# **Intel® 450NX PCIset Specification Update**

Release Date: February 1999

Order Number: 243848-008

The Intel® 450NX PCIset may contain design defects or errors known as errata which may cause the product to deviate from published specifications. Current characterized errata are documented in this Specification Update.

**Figure 2. Timing Window Where Strobe Falling Edge Must Be Avoided**

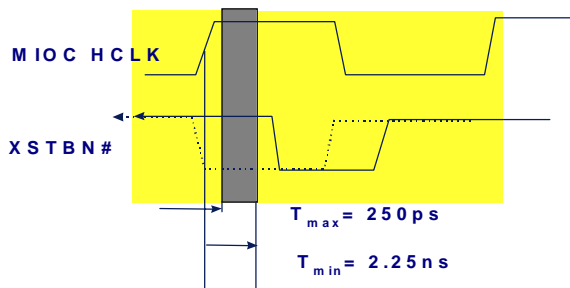
**PROBLEM:** The MIOC component erroneously checks parity on the expander (F16) bus during the turn-around cycle immediately following a PXB-driven packet and the start of an MIOC-driven packet. If a very specific timing relationship exists between the MIOC's clock and the arriving XSTRB# signals exists (XSTRBN# strobe falling-edge arrives at the MIOC right coincident with the start of the data bus being driven by the MIOC), data and parity sampled by the strobes may be inconsistent due to bit-skew and/or metastability. An F16 Bus Parity Error may be erroneously flagged.

**WORKAROUND:** The failure band is narrow enough that slightly varying XSTBN# falling-edge arrival with respect to MIOC's data-output timing can prevent the failure from occurring. Delaying XnCLK from the MIOC to the PXB can vary this timing and can be accomplished by adding extra loading or trace-routing to the XnCLK signal routing (if adjusting the entire F16-bus routing is not feasible due to existing board layout). To assist in designing board layout for avoidance of this problem, consider calculating the sum of the following system timing parameters and comparing against the limits of the failure band or timing "window."

$$HCLK / XpClkFB \text{ Skew} + XpClkFB / XpClk \text{ Skew} + T_{66} + XpXSTBN\# \text{ Flight time} \leq (T_{PERIOD} + 250 \text{ ps}), \text{ or } > (T_{PERIOD} + 2.25 \text{ ns})$$

Implementing this workaround may require deviating from the clock-skew specification. The skew between XpClkFB at the MIOC and XpCLK at the PXB may need to increase to account for a delay to the XpCLK line. Note that due to min/ max parameter variances, it may not be possible to design a workaround which can guarantee avoidance of the failing timing scenario, at least not without violating other timings. If this is the case, calculating the above timing and comparing min/ typ/ max values may still provide some assistance in designing a system workaround which could minimize exposure to this problem.
